INDEPENDENT GEOTECHNICAL PEER REVIEW HOOVER SLIDE SECTION PROVO CANYON

US-189: WILDWOOD TO
DEER CREEK STATE PARK

NH-0189 (6) 14

**INDEPENDENT GEOTECHNICAL PEER REVIEW
SR-189 HOOVER SLIDE SECTION, PROVO CANYON
WILDWOOD TO DEER CREEK STATE PARK**

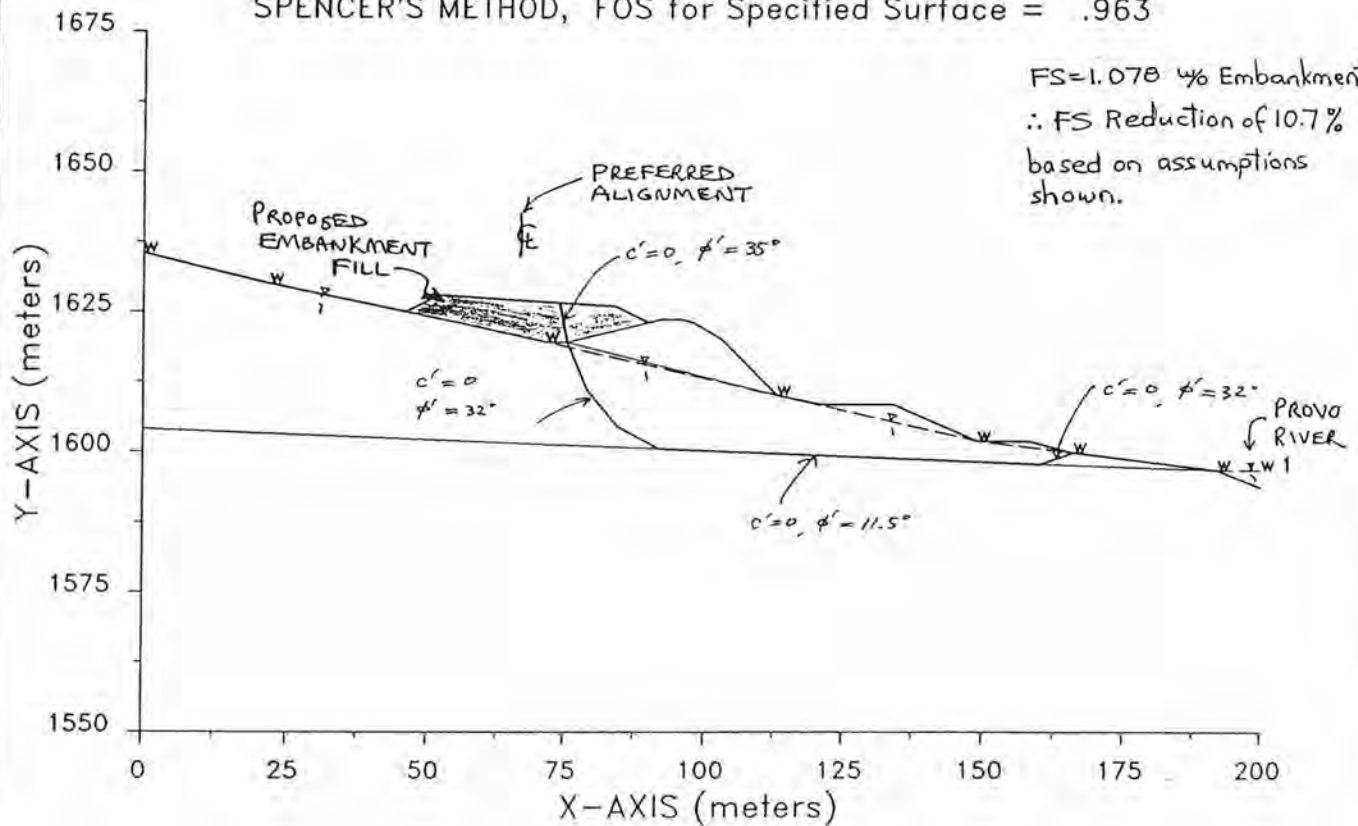
The preliminary analyses demonstrate that slope stability could decrease if an earthfill embankment is placed upslope of the existing highway. Decreases in the Factor of Safety of up to 11 % were calculated. If the existing Factor of Safety is marginal, i.e. less than 1.2, instability could result from embankment placement. The likelihood of instability would increase if the embankment foundation were subjected to critical groundwater conditions in an extremely wet season. Figure 5 presents a representative conceptual stability analysis cross section, with assumed parameters.

SPENCER'S METHOD, FOS for Specified Surface = .963

FS=1.078 w/ Embankment
∴ FS Reduction of 10.7%
based on assumptions
shown.
